Access Compliance Report Public Rights-of-Way (Curb Ramps)

Main Street: HALF_MOON_TRAIL		Cross Street: IRON_HORSE_TRAIL		Location:	S
ADA ID: RPRK211021131958	Ramp Type: Type 4 - Parallel	Initial Pass/Fail: Fail	Overall Compliance: No	Severity Score:	16
Codes/Mitigation Info/Possible Solution			Field Measurements/Component Compliance

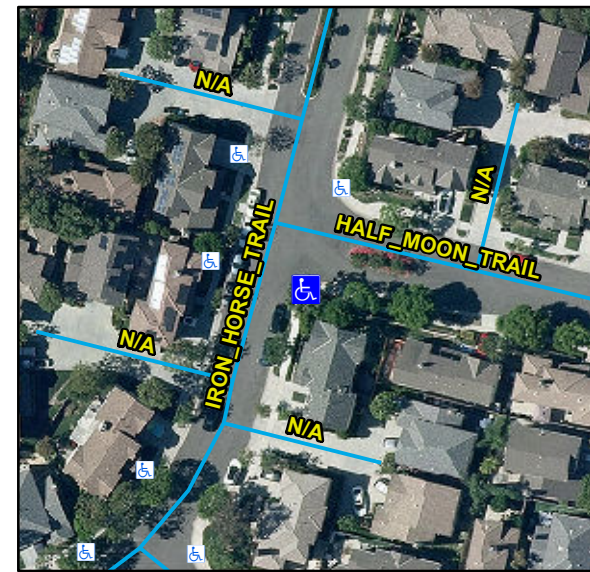
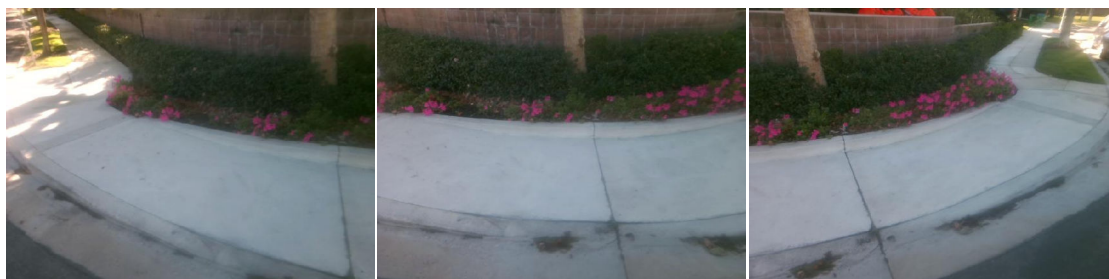
R204.3, R304.3.2, STD 1115

Compliance	Description	Data	Compliance	Description	Data
N/A	Ramp Length LT (in)	114	N/A	Ramp Length RT (in)	118
Yes	Ramp Width LT (in)	53	Yes	Ramp Width RT (in)	53
Yes	Ramp Run Slope LT (%)	3.2	No	Ramp Run Slope RT (%)	8.6
Yes	Ramp Cross Slope LT (%)	2	Yes	Ramp Cross Slope RT (%)	0.4
N/A	Landing Present	N/A	N/A	DWS Provided	N/A
N/A	Landing Length (in)	N/A	N/A	DWS Contrast	N/A
N/A	Landing Width (in)	N/A	N/A	DWS Length (in)	N/A
N/A	Landing Run Slope (%)	N/A	N/A	DWS Full Width	N/A
N/A	Landing Cross Slope (%)	N/A		DWS Offset Type	N/A
N/A	Landing Movement Obstructed?	N/A	N/A	DWS Offset Left (in)	N/A
	Landing Movement Type	N/A	N/A	DWS Offset Right (in)	N/A
N/A	Landing Shared	N/A			
N/A	Clear Space	Yes			
N/A	Clear Space To Crosswalk (in)	N/A			
N/A	Marked Crosswalk 1	No	N/A	Marked Crosswalk 2	No
	Crossing 1 Direction	NE		Crossing 2 Direction	NW
	Marked Crosswalk 1 Width (in)	N/A		Marked Crosswalk 2 Width (in)	N/A

Remove & Replace Curb Ramp With Two New Directional Ramps or Equivalent.
